# Daimler Trucks North America LLC

**December 2016**  
**Recall FL727A**  
**NHTSA #16V-809**

## **IMPORTANT SAFETY RECALL** **See enclosed VIN List**

### **Subject: FCCC Motorhome Power Steering Hose Routing**

**Fig. 1, Power Steering Hose with P-Clip (body removed for clarity)**

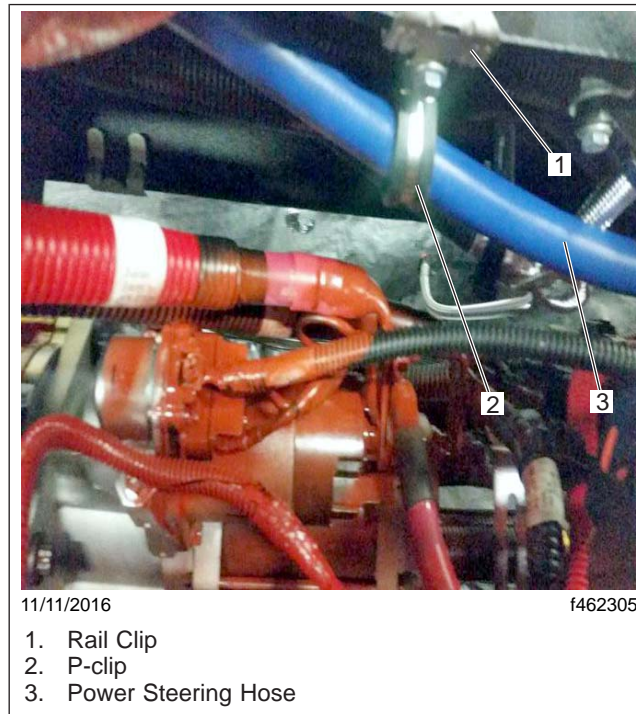
On certain motorhome chassis, the high pressure power steering hose may be routed with inadequate clearance between the hose and a power stud on the starter motor. This may cause the hose to chafe against the power stud on the starter, potentially leading to arcing and, in addition, may cause loss of fluid, short circuit, and melting. Electrical arcing in the presence of leaking power steering fluid can increase the risk of a fire.

- 6.1 If the power steering hose is held with a P-clip near the starter stud, no work is needed. See [Fig. 1](#). Clean a spot on the base label (Form WAR259). Write the recall number, FL727, on a completion sticker (Form WAR260), and attach it to the base label.

1. Install a rail clip on the top flange of the frame rail, just above the starter.
2. Using a P-clip, bolt, nut, and washer, secure the power steering hose on the rail clip. See [Fig. 1](#). Tighten the nut 72 lbf-in (813 N-cm).
3. For additional security, install tie bands around the hose to the harness near the frame rail within 18 inches (46 cm) of the P-clip.
4. Clean a spot on the base label (Form WAR259). Write the recall number, FL727, on a completion sticker (Form WAR260), and attach it to the base label.
